# Intel® Quark™ SoC X1000

## Specification Update

*February 2015*

### 12.7.3.1 ECC Scrubber Configuration Register (P\_CFG\_50)—Offset 50h

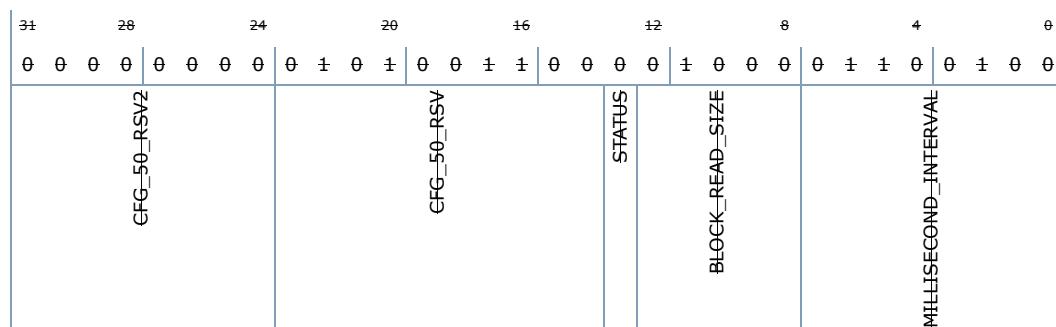
### 1. ECC Scrubbing Has Been Defeatured and is No Longer Supported on the Intel® Quark™ SoC X1000

Old Text: ECC Scrubber Registers (Offsets 50h, 76h, 77h, 7Ch) have been removed.

New Text: Section 12.3.1 ECC Scrubbing has been removed.

### 12.6.2 SPI DMA Block

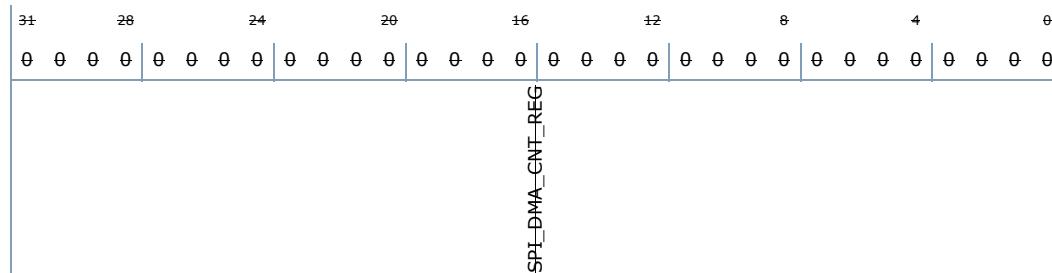
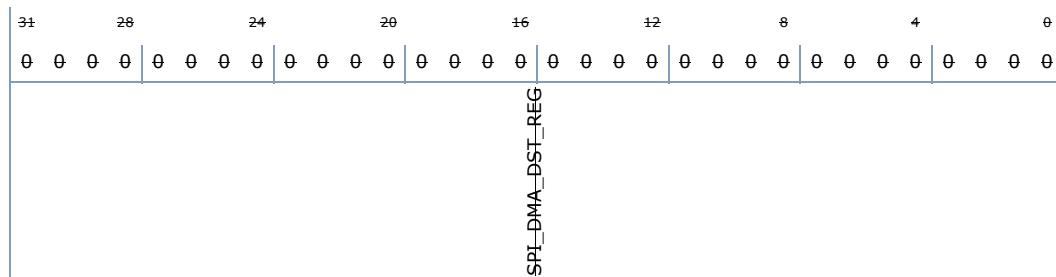
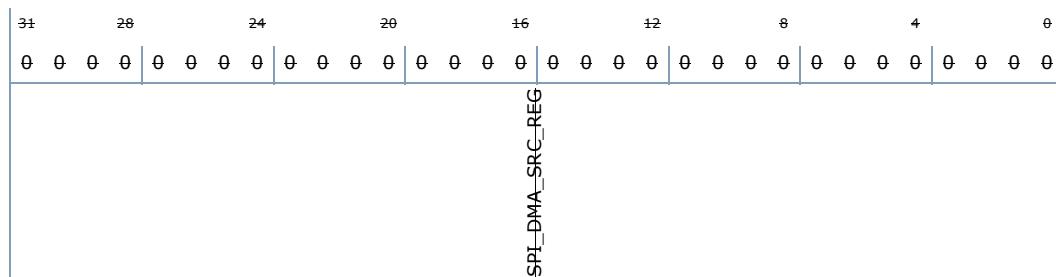
### Remote Management Unit DMA via IOSF Primary is No Longer Supported on the Intel® Quark™ SoC X1000

Issue: The Intel® Quark™ SoC X1000 uses only the sideband option for setting up a DMA transfer.

New Text: Section 12.6.2 has been removed.

#### 12.6.2.3 Option Register 1(P\_CFG\_72) —Offset 72h

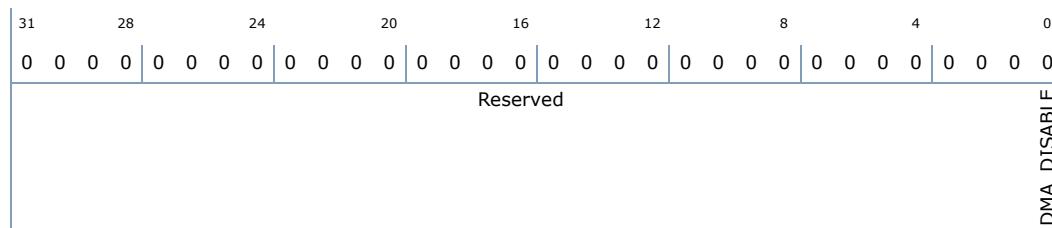
### 3. Lock Out DMA Capability Past Boot

Issue: DMA functionality must be disabled on boot completion to prevent an attacker from using it to take control of the system.

New Text: A new register is added:

Bit Range	Default & Access	Field Name (ID): Description
31:1	0 RO	Reserved (RSVD): Reserved.
0	0 RW	DMA_DISABLE: Remote Management Unit DMA disable. Once set RMU DMA functionality is disabled until system reset
